City of Detroit  
Inter-Departmental Communication

**RE:** Petition No. 517  
Requested Berm Parking into W. Seven Mile Rd. and Strathmoor Ave. at 14500  
W. Seven Mile

**NOTICE OF PROPOSED CHANGE IN PROPERTY**

**REQUEST BERM USE  
 (For Parking Only)  
 INTO W. SEVEN MILE RD.  
 AND STRATHMOOR AVE.  
 AT 14500 W. SEVEN MILE RD.**

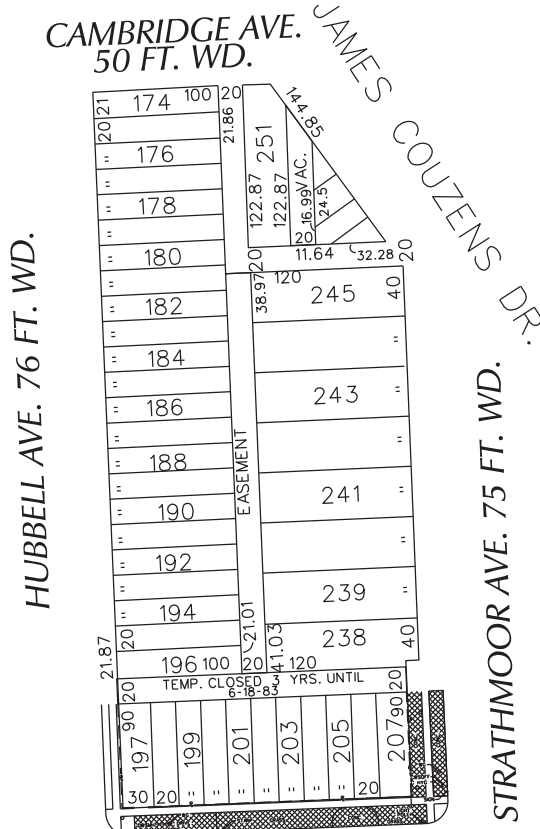
- Our records show that there are sewers and water mains in the vicinity of the area requested for berm parking. However, DWSD has no objection to the use of the berm for parking provided that the petitioner follows the attached provision for encroachment.

Detroit Water and Sewerage (DWSD) agree to the proposed encroachment subject to the fulfilling of the following provisions:

1. By approval of this petition the (DWSD) does not waive any of its rights to its facilities located in the right of way, and at all time, DWSD, its agents or employees, shall have the right to enter upon the right of way to maintain, repair, alter, service, inspect, or install its facilities. All costs incident to the damaging, dismantling, demolishing, removal and replacement of structures or other improvements herein permitted and incurred in gaining access to DWSD's facilities for maintenance, repairing, alteration, servicing or inspection caused by the encroachment shall be borne by the petitioner. All costs associated with gaining access to DWSD's facilities, which could normally be expected had the petitioner not encroached into the right of way shall be borne by DWSD.

2. All construction performed under this petition shall not be commenced until after five (5) days written notice to DWSD. Seventy-two (72) hours notice shall also be provided in accordance with P.A. 53 1974, as amended, utilizing the MISS DIG one call system.

3. Construction under this petition is subject to inspection and approval by DWSD forces. The cost of such inspection shall, at the discretion of DWSD, be borne by the petitioner.

4. If DWSD facilities located within the right of way shall break or be damaged as the result of any action on the part of the petitioner, then in such event the petitioner agrees to be liable for all costs incident to the repair, replacement or relocation of such broken or damaged DWSD facilities.

5. The petitioner shall hold DWSD harmless for any damage to the encroaching device constructed or installed under this petition, which may be caused by the failure of DWSD's facilities.
